Subject: Transmittal of Revision 1 To Service Bulletin Number
V25000-ENG-72-0291.

ENGINE - STAGE 1 HIGH PRESSURE TURBINE VANE CLUSTER ASSEMBLY - PROVIDE A NEW
FULLY CAST STAGE 1 HIGH PRESSURE TURBINE VANE ASSEMBLY

V2500-ENG-72-0291

Location of the Stage 1 High Pressure Turbine Vane Assembly
Figure 1

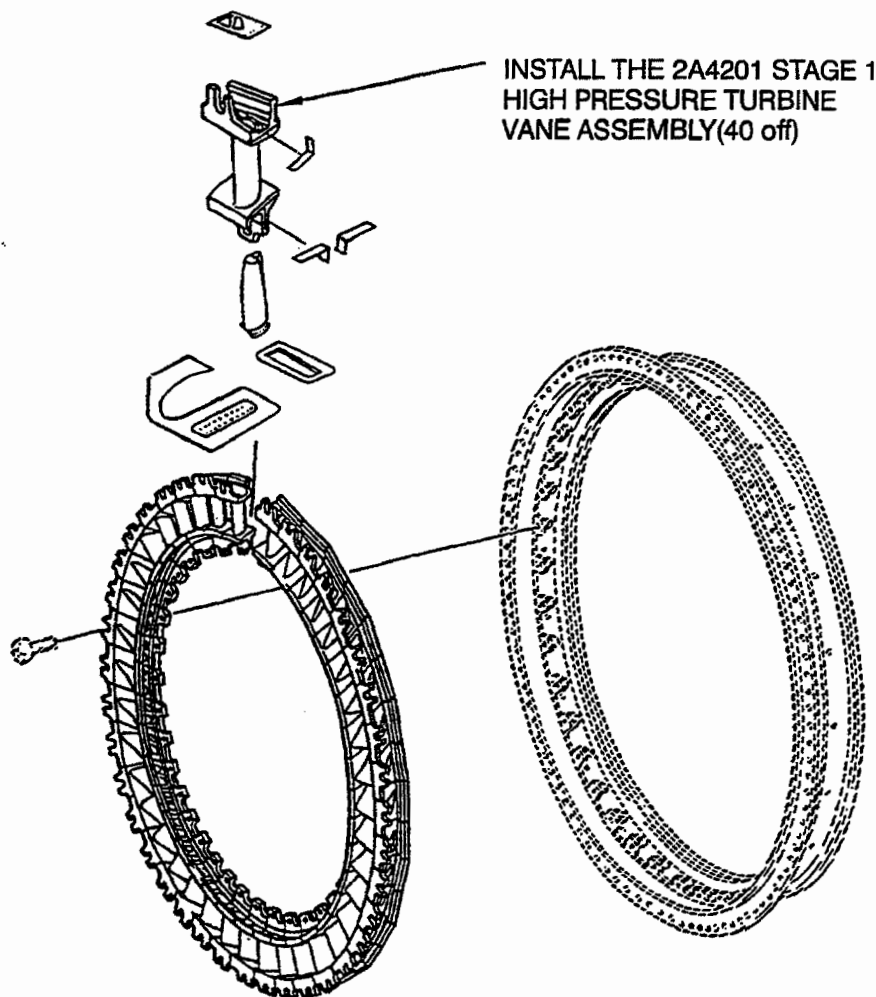
- (1) Replace the 2A2761 Stage 1 High Pressure Turbine Vane Assembly with the 2A4201 Stage 1 High Pressure Turbine Vane Assembly.

- A. Install the 2A4201 Stage 1 High Pressure Turbine Vane Assembly (40 off) by the procedure given in Reference (3) or (4), Chapter/Section 72-44-00, Assembly.

Family Tree - Stage 1 HPT Vane Assembly
Ref. Catalog Sequence No 72-44-20. Fig. 1 Item 240
Figure 2

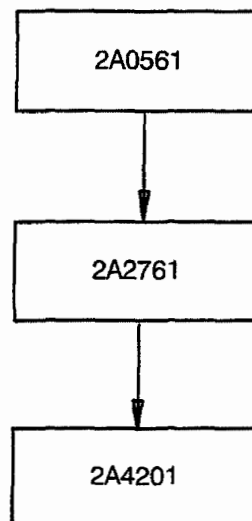
V2500-ENG-72-0291
ENGINE - STAGE 1 HPT VANE
CLUSTER ASSEMBLY - PROVIDE
A NEW FULLY CAST STAGE 1
VANE ASSEMBLY
